Technical Bulletin 220

10.2021

Contents

Identification

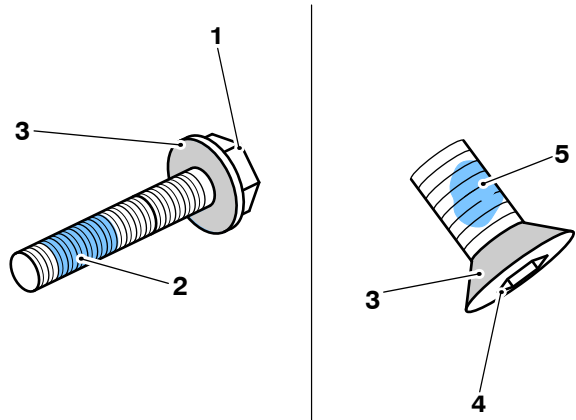
When carrying out any maintenance or repairs, unless a specified repair procedure states otherwise, encapsulated or patch locked fixings if disturbed or removed must be discarded and replaced with new. Encapsulated fixings can be identified on the Electronic Parts Catalogue (EPC) by the text 'Enc' in the part description. Patch locked fixings can be identified on the Electronic Parts Catalogue (EPC) by the text 'Pat' in the part description.

- The motorcycles Service Manual will indicate where encapsulated fixings are used and the recommended torque tightening procedure.
- Thread locking compound must not be used except where stated in the appropriate service instructions.
- An encapsulated fixing can be identified when the diameter of threads is encompassed by the locking agent.
- A patch locked fixing can be identified by a section of thread which is treated with a coloured locking agent.

- 1. Slider (smooth side)
- 2. Slider (grooved side)
- 3. Area to grease

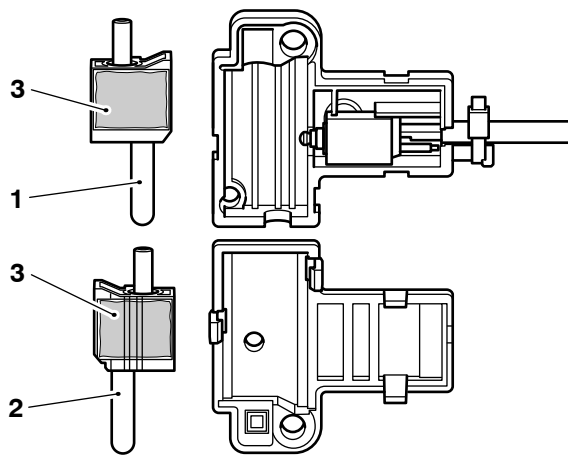
A small number of the above models have seen the clutch switch slider stick in its housing.

In certain circumstances, this may cause the engine not to start.

Applying a small amount of grease to the square area of the slider eliminates this.

6. Apply a smear of a silicon based grease to both sides of the slider as shown below.

1. Selector shaft
2. Detent wheel
3. Auxiliary chain guide
4. Cable tie (for transportation only)

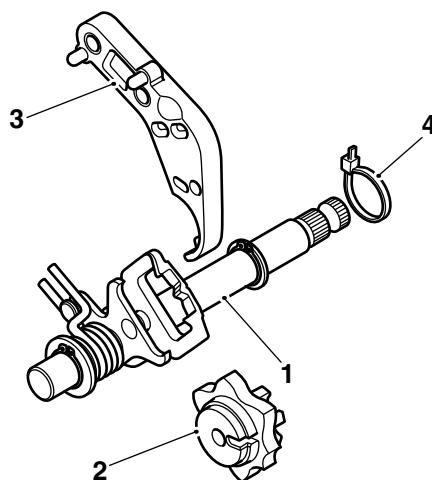
Parts kit T1191968 has been replaced by T1191977.

Parts kit T1191977 has been released for use when replacing the gear change selector mechanism. The kit consists of a fully assembled selector mechanism an auxiliary chain guide and a detent wheel.

Always remove and discard the (black coloured) auxiliary drive chain guide.

Failure to fit the replacement (natural coloured) auxiliary drive chain guide will stop the correct operation of the gear change selector mechanism.

- The washer at the splined end of the selector shaft is retained by a cable tie for transportation purposes. The cable tie must be removed and discarded before installing the selector shaft.
